1418-1432 WESTBROOK STREET

At 1418-1432 Westbrook Street-I

AP 1412-1432 Westbrook Street-I

A check of the plans filed with the application for permit for construction of a one family dwelling and attached garage at 1412-1432 Westbrook Street raises several questions as to construction about which more information is needed before a permit may be issued. Details in question are as follows:

Westbrook Street

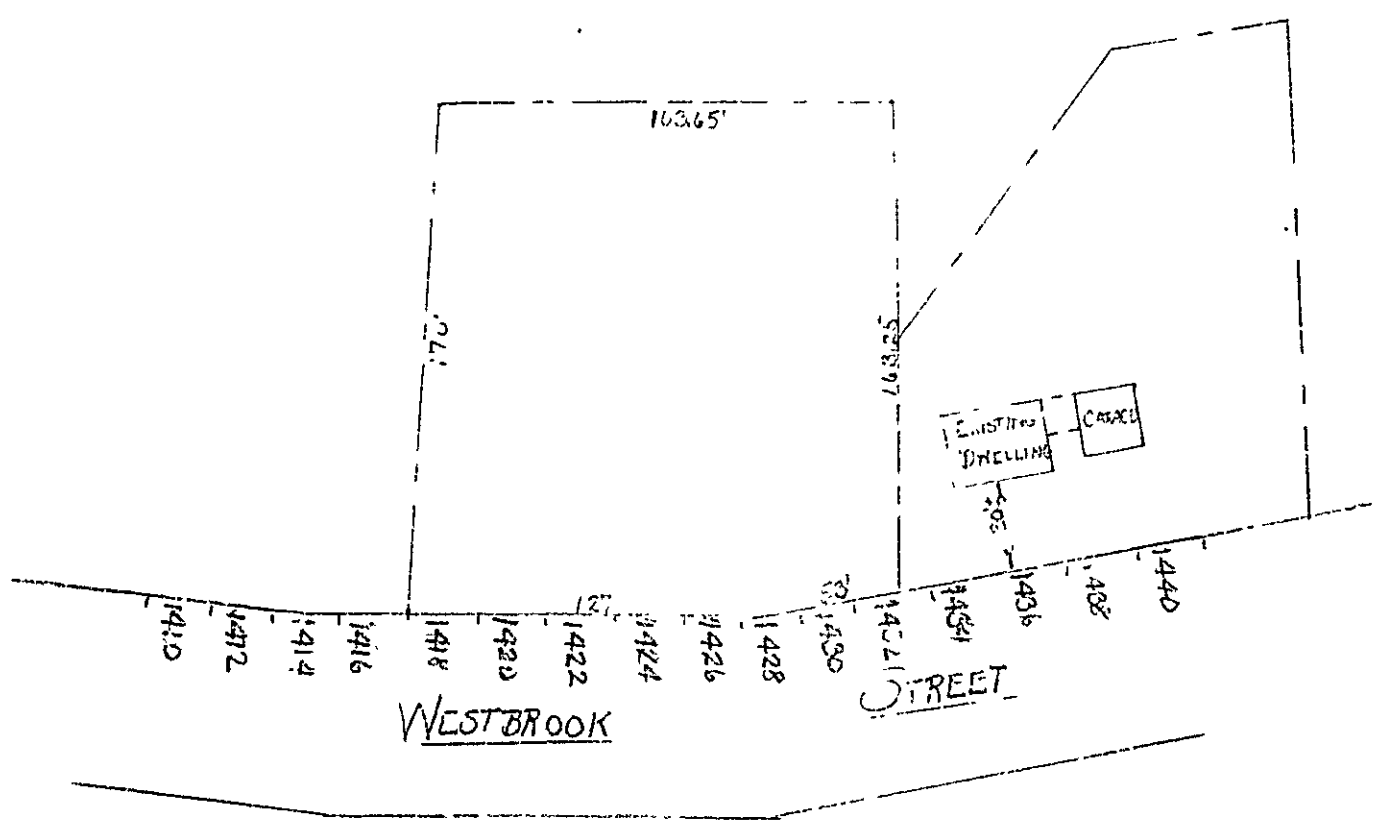
THAT NO CONCRETE SHALL BE POURED IN FOUNDATION FORMS AND NO
LAYING OF UNIT MASONRY IN FOUNDATION WALLS SHALL BE STARTED UNTIL
NOTICE HAS BEEN GIVEN AT THE DEPARTMENT OF BUILDING INSPECTION OF
READINESS TO START ACTUAL MASONRY WORK, AND UNTIL RE-CHECK OF
LAYOUT HAS BEEN MADE BY INSPECTOR.

Original markings of corners of lot and especially stakes on
street line set by Dept. of Public Works must be kept intact and
easily accessible for re-check -- not covered by excavated earth
or building materials. Otherwise the "go-ahead" cannot be given.
Dept. of Public Works cannot reset their stakes.
